**RE: April 2, 2025, Sacramento LAFCO Meeting, Agenda Item V-6
Comments on the Airport South Industrial Project and Its
Final Environmental Impact Report**

On behalf of Sierra Club, Environmental Council of Sacramento (“ECOS”) and Friends of Swainson’s Hawk, this letter provides comments regarding the Airport South Industrial Project (“Project”) and its Final Environmental Impact Report (“FEIR”).

Figure 1. Accumulation of wildlife species detections at a Sacramento-area site over 41 surveys, ending at 149 species. However, the pattern in the data indicates via modeling that 191 species would eventually be detected after additional surveys.

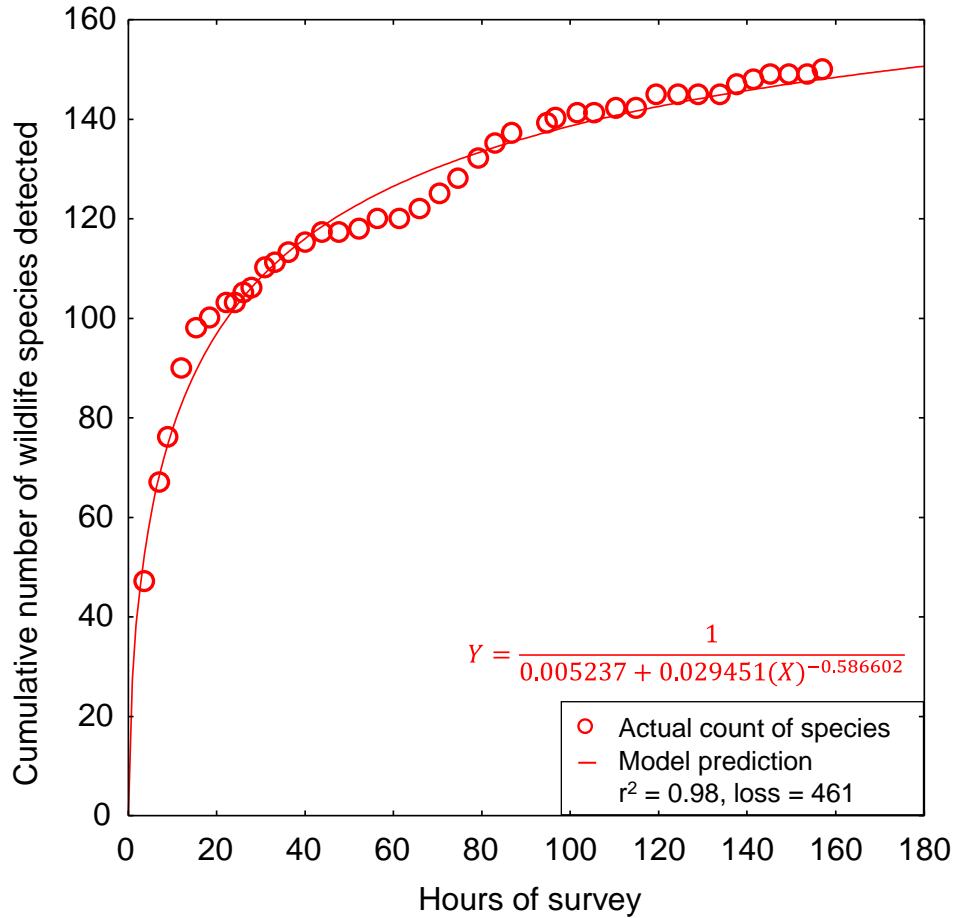
The response alleges my model (1) overstates the number of species that occur on the site due to bias, and (2) infers few species were detected each survey. It is unclear to which model the response refers, it provides no evidence of the alleged bias, and it neglects to explain how the bias came about. On these points, the response asserts empty accusations of bias and misdirected inference.

It is unclear which model the response alleges to be biased, considering that the response spans my comments addressing three models, the first depicted in Figure 1, the second depicted in the text on page 18, and the third depicted in Figure 2 of my 16 July 2024 comment letter. Even less clear is that portion of the response that claims my model infers “few species were detected each survey.” My final point on this lack of clarity is that it is not the model that draws inferences, but rather the analyst making use of the model. I fail to understand the point of the response regarding inference pertaining to bias and surveys.

Figure 2. The probability of detection of white-tailed kite at a given site within its geographic range in California is a function of both survey duration and proximity of occurrence records in eBird.

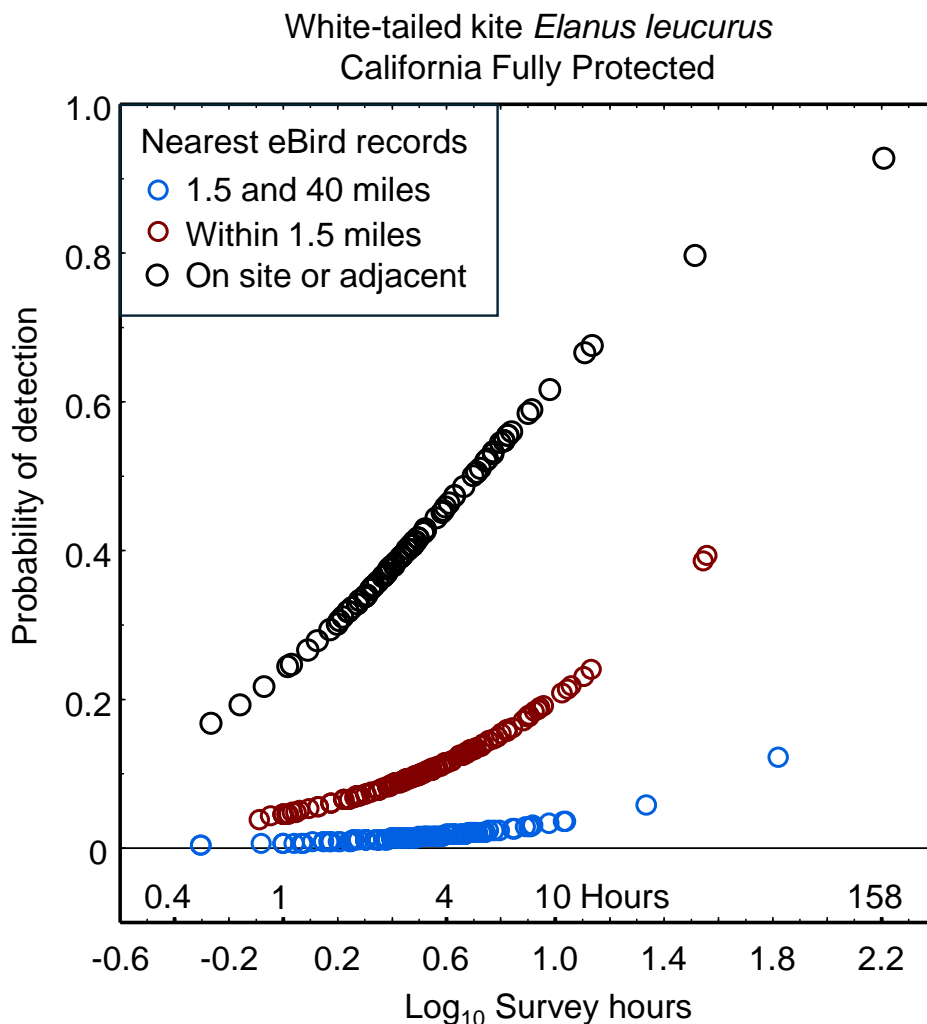
Reply: The response is inaccurate because it is looking at our proximity domains (within 1.5 miles, between 1.5 and 4 miles, and between 4 and 30 miles in the case of my letter of 16 July 2024) in the wrong way. The proximities of occurrence records serve as a useful predictor of the likelihood of detection of a species on a given site (Figure 2). As shown in this case for white-tailed kite, occurrence records that are more distant from a site decrease the likelihood of detection at a given level of survey effort, but they do not

preclude detections altogether (consistent with the tenet that occurrence records should not lead to determinations of absence). More distant records more accurately inform of the need for greater survey effort to detect the species on the site. In the example of the white-tailed kite, the addition of proximity domains informs us that to achieve a 10% likelihood of detection, even a brief survey should be all that is needed if the nearest occurrence record was on site or adjacent to the site, but four hours would be needed if the nearest record was within 1.5 of the site, and 10 hours would be needed if the nearest record was between 1.4 and 40 miles of the site.

Figure 3. eBird occurrence records (teardrop symbols, where red symbols identify

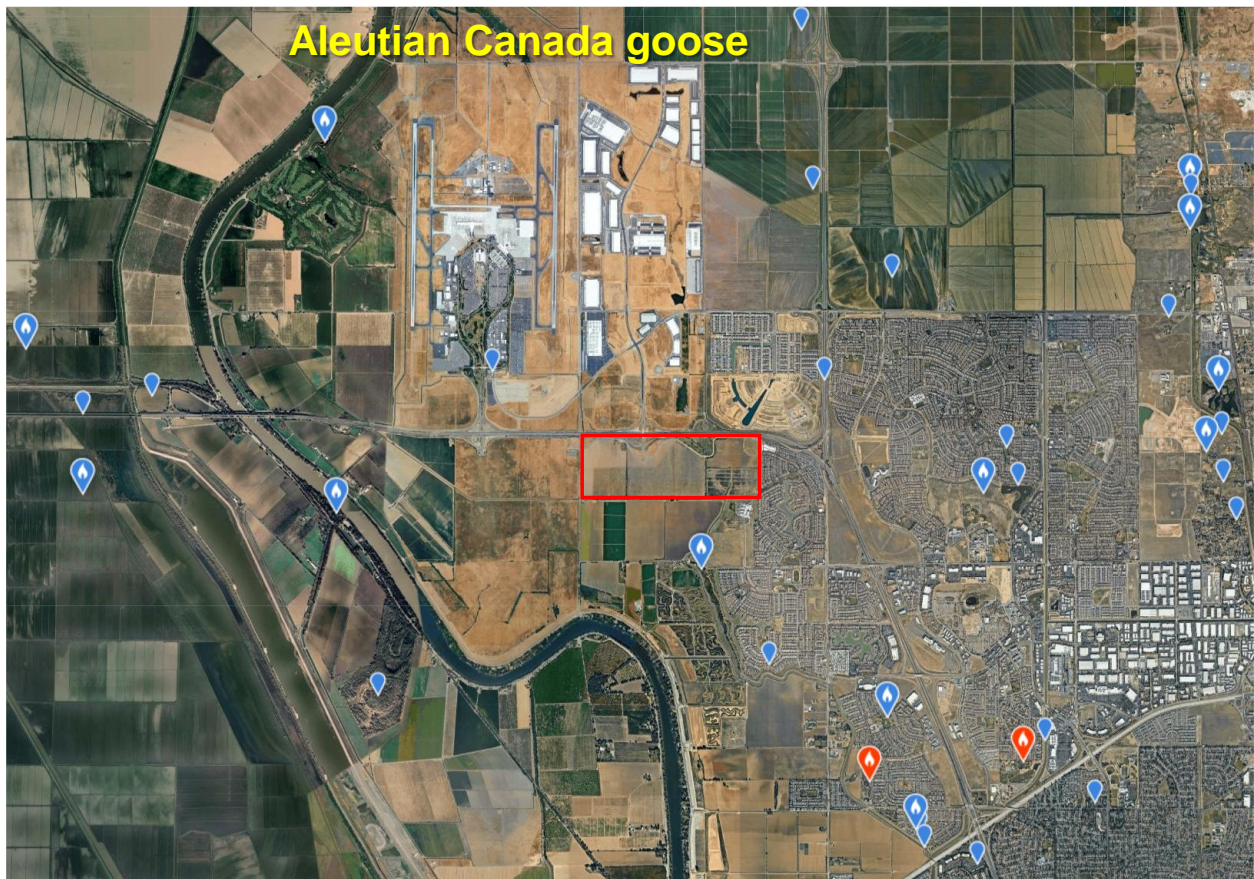
Reply: It is not true that the DEIR determines the Aleutian Canada goose and white-faced ibis are not expected to occur on the project site. The determination for both species is of low likelihood of occurrence. Bargas assigns its low occurrence likelihood to “Species with few known recent recorded occurrences/populations near the Biological Study Area and habitat within the Biological Study Area is highly disturbed or extremely limited.” A different standard is applied to species not expected to occur. This error of the response pointed out, I will add that I disagree even with the DEIR’s assignments of low occurrence likelihoods. I have seen Aleutian Canada goose and white-faced ibis all around the project site. Furthermore, there are many eBird occurrence records of both species around the project site (Figures 3 and 4), all of which add to the likelihoods that both species occur on the site (indeed, one record of white-faced ibis is on the site).

The addition of 86 acres of detention basins would increase the likelihoods of occurrences of these species on the project site, unless, that is, the Wildlife Hazard Management Plan would resort to extreme or even lethal measures to discourage them (more on this below).
